# CITY OF ALBUQUERQUE

**RE: 2900 3<sup>rd</sup> Street NW**  
**Grading & Drainage Plan**  
**Engineer's Stamp Date: 5/29/25**  
**Hydrology File: H14D118**  
**Case # HYDR-2025-00196**

ENGINEER'S SEAL	3RD AND PHOENIX TOWNHOMES	DRAWN BY WCWJ
DAVID SOULE 14522 PROFESSIONAL ENGINEER	GRADING AND DRAINAGE PLAN	DATE 9-08-23
5/29/25	Rio Grande Engineering PO BOX 93924 ALBUQUERQUE, NM 87199 4967.50	SHEET #
P.E. #14522 DAVID SOULE		JOB # 20230047

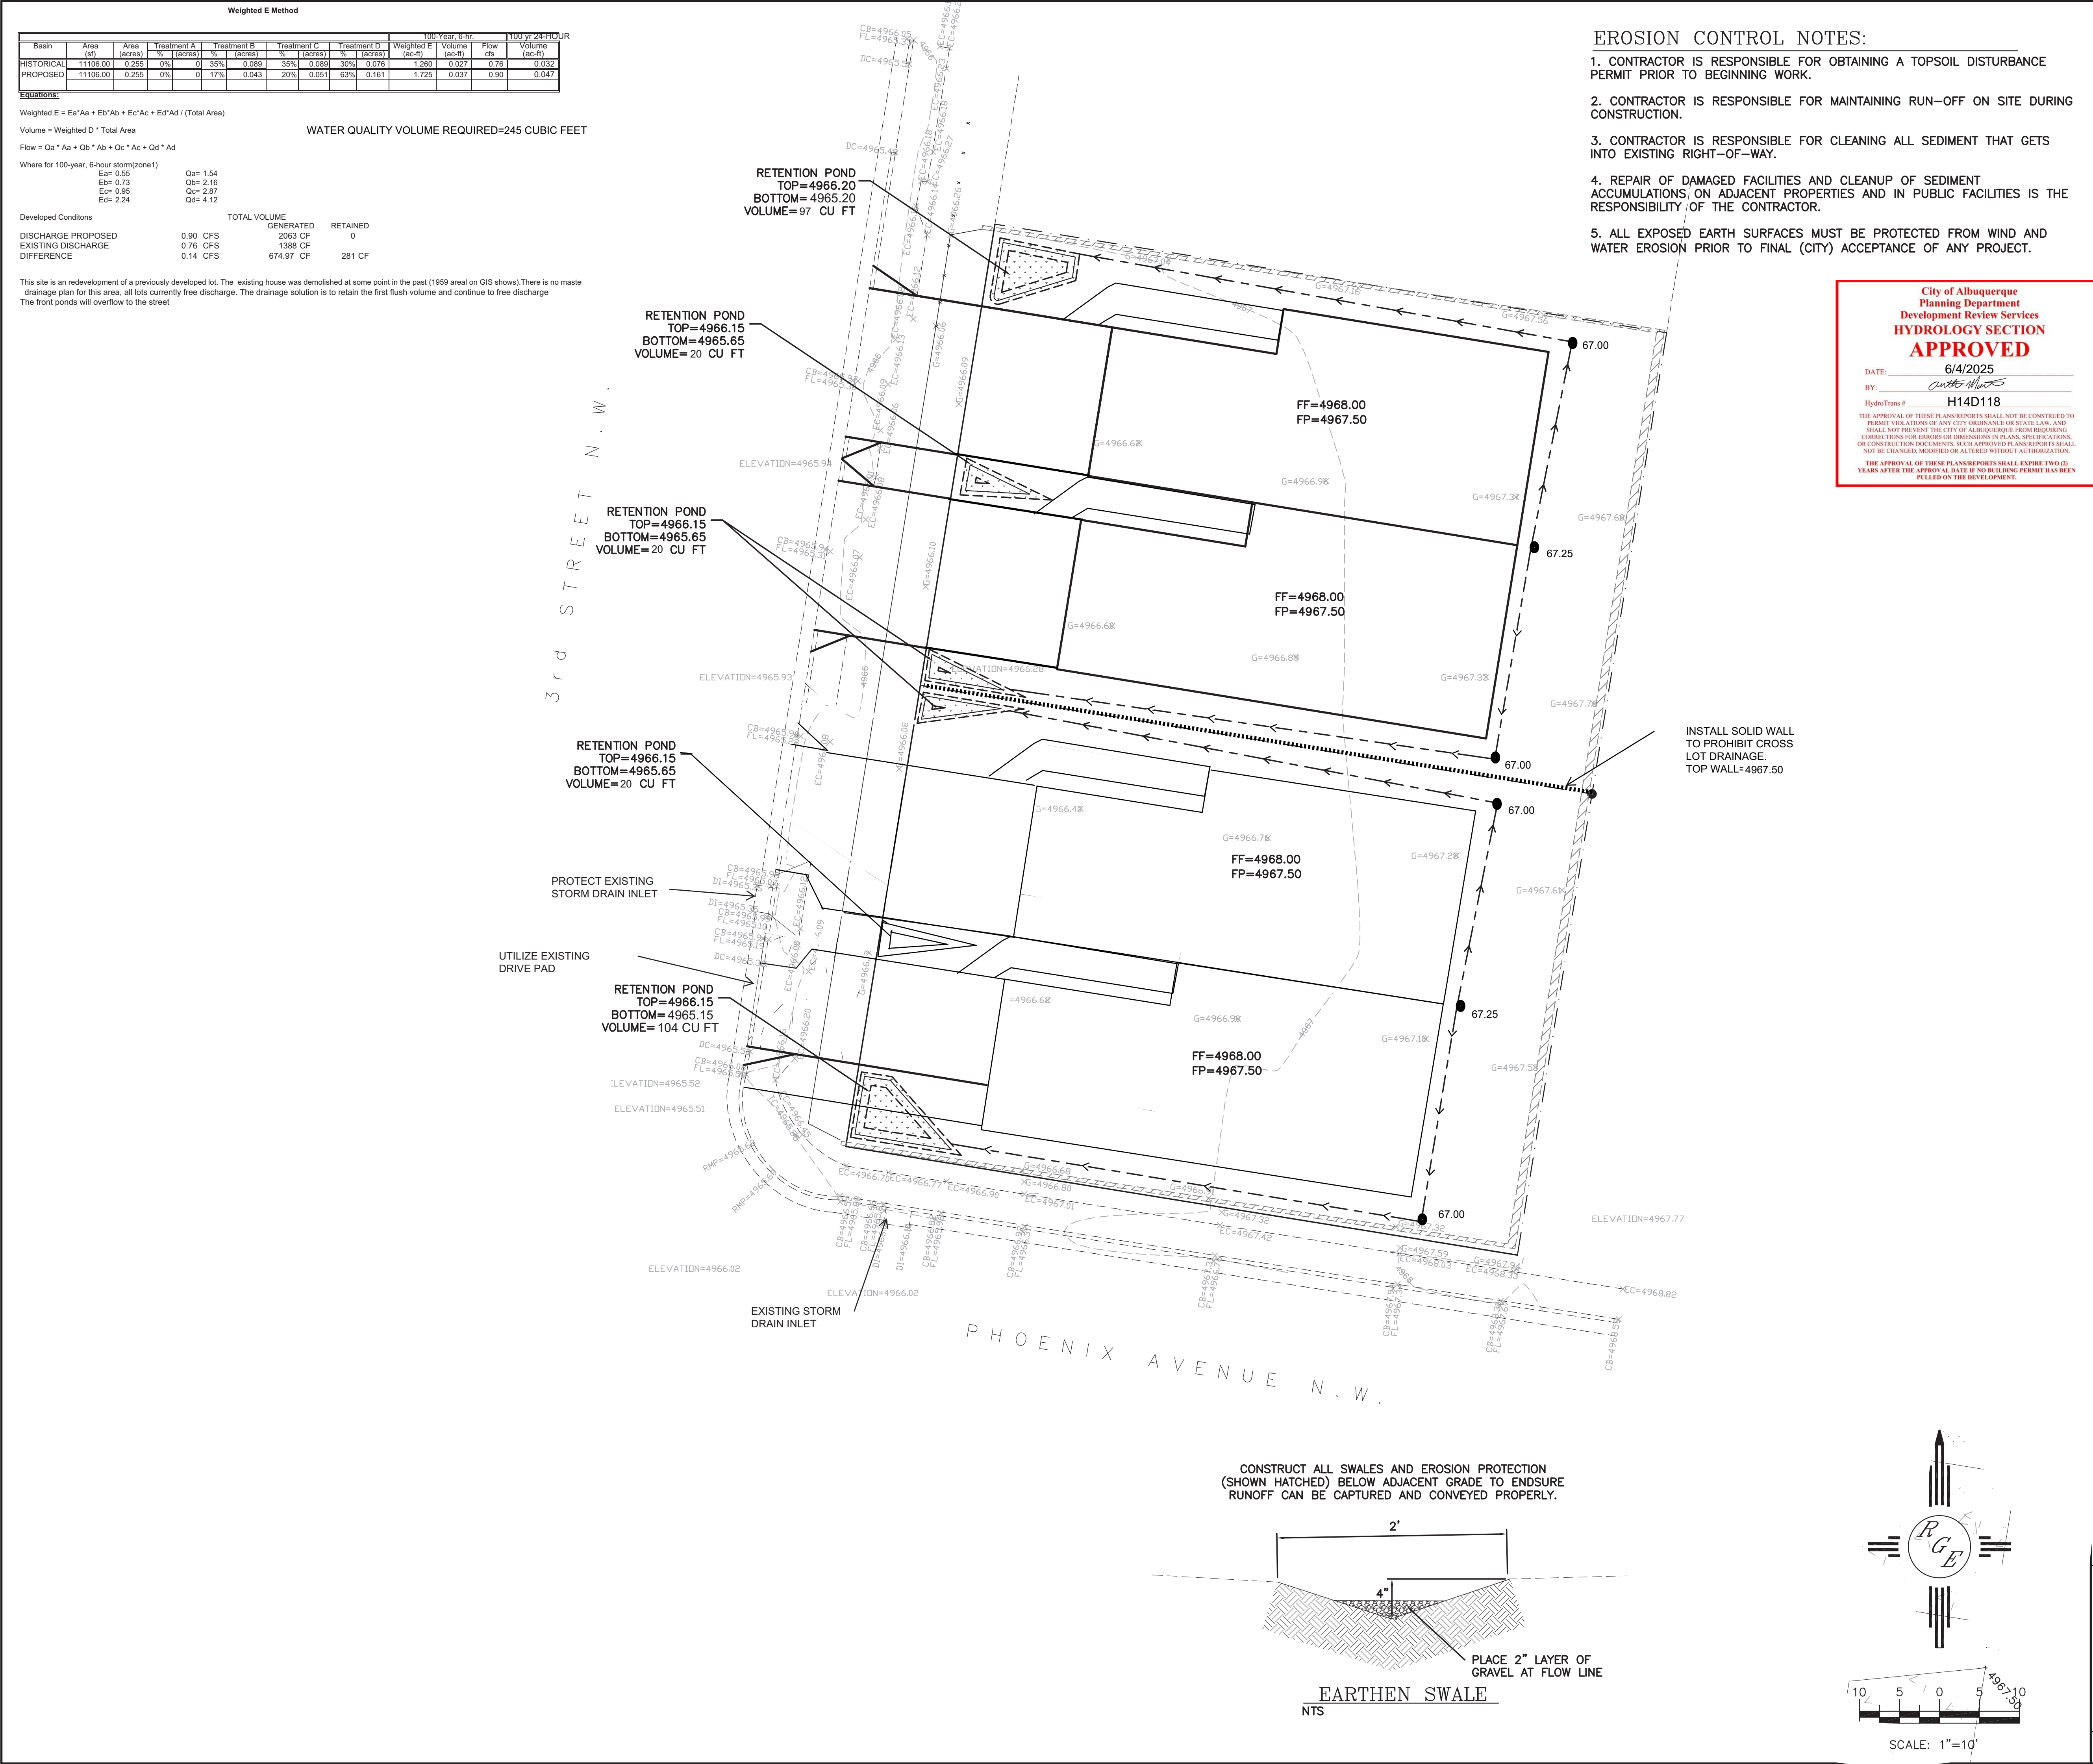
Based upon the information provided in your submittal received 6/02/2025, the Grading plan is **approved** for Building Permit. Please attach a copy of this approved plan in the construction sets for Building Permit processing along with a copy of this letter.

1. Engineer's Certification, per the DPM Part 6-14 (F): *Engineer's Certification Checklist For Non-Subdivision* is required.
